DEVIATION REQUEST AND DECISION FORM

Project Name :	Yucatan Convenience Store
Schedule No.(s) :	6501205016
Legal Description :	Lot 1 Clearview West Filing No. 2 (4815 Yucatan Dr. Colorado Springs, CO 80911)

A deviation from the standards of or in Section **2.3.7.D.2** of the Engineering Criteria Manual (ECM) is requested.

Figure 2 - 6. Guideline for determining the need for a major-road right-turn bay at a two-way stop-controlled intersection.

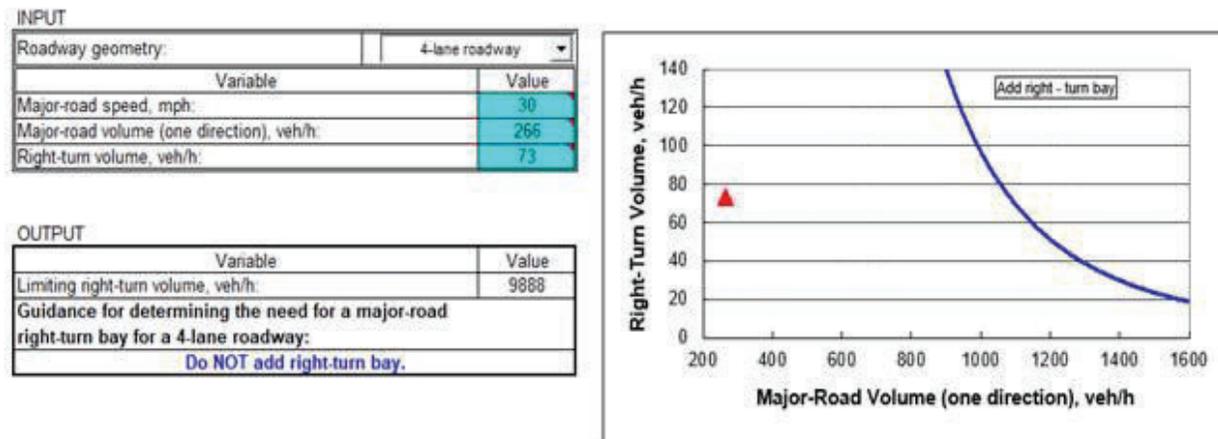
As you can see in Figure 2-6 below, the data point representing this site and its traffic/access volumes does not remotely approach meeting the threshold for suggested implementation of a right turn lane. A right turn volume of 73 veh/hr would require over 1000 veh/hr of through-traffic to be considered disruptive enough to warrant a right-turn lane (Compared against the Major-Road Volume of 266 veh/hr, a volume almost a quarter of that. This indicates that utilizing a through lane for right-turns onto the site will not be disruptive to through-traffic, nor to the functionality of the roadway or the Hancock/Yucatan intersection.

Because the through-traffic volume required (based on NCHRP 279 guidelines) to warrant a separate right-turn lane at the right-turn volume for this site (73 veh/hr) is nearly 4 times the actual through-traffic volume (>1000 veh/hr vs. 266 veh/hr), the factor of safety and level of operational functionality will not be negatively impacted by utilizing a through lane for right-hand turns onto the site.
